Type Coffee Vending Machine	Model OPERA TOUCH	N° T.I. 05_2023
Serial Number 31921663	Subject CPU BOARD MODIFICATION

Type Coffee Vending Machine	Model OPERA TOUCH	N° T.I. 05_2023
Serial Number 31921663	Subject CPU BOARD MODIFICATION

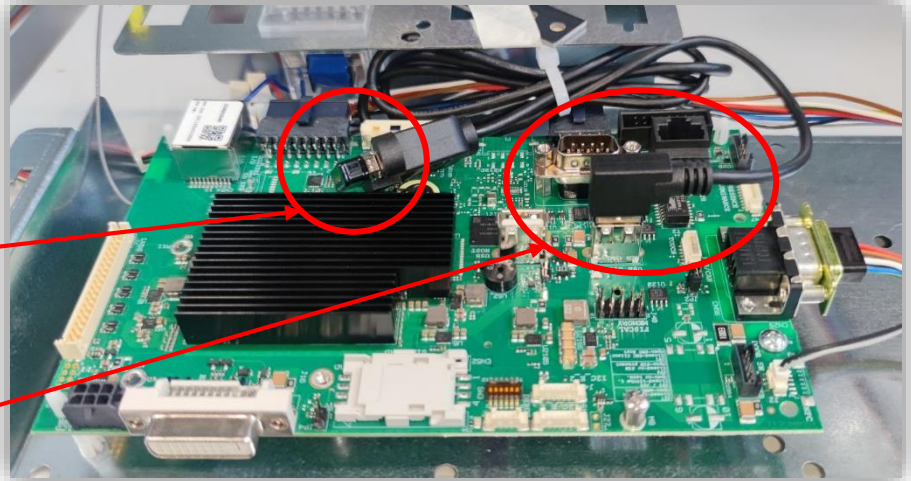
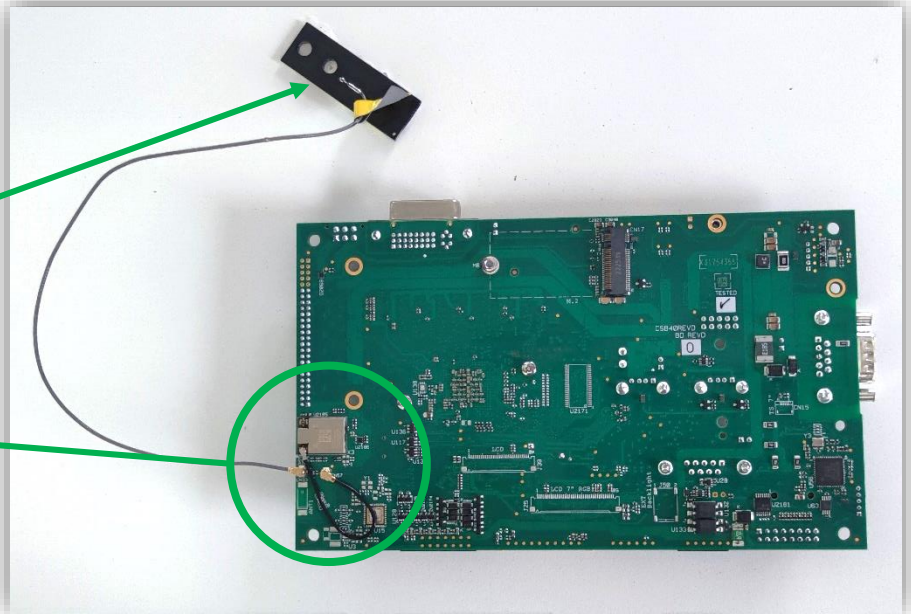
Wi-Fi and Bluetooth chip available again

Introduction of a new CPU board with integrated *Wi-Fi and Bluetooth* chip

Pre – modification CPU board (no Wi-Fi /BT chip) with Dongle and Extension

New CPU board
(with Wi-Fi / BT chip) Spare code: **266090 sap 55126744**

Wi-Fi / BT aerial
(not supplied with CPU board)
Spare code: **261292 sap 55121111**

Wi-Fi / Bluetooth chip

For machines prior to above S/Ns, if it is necessary to replace the CPU board, the **new** CPU board must be used, spare code **266090**.

The **new** CPU board can run only with the SW *Application Key 2* below:

➤ Opera Touch: **Key 2** rev. **1.12.23** or later.

These SW *Application Key 2* versions are also compatible with the **pre – modification** CPU board, spare code **265669**. Therefore, if you want to update the machines SW, without replacing the CPU board, (keeping the **pre - modification** CPU in the machine) you can do it without any additional action.
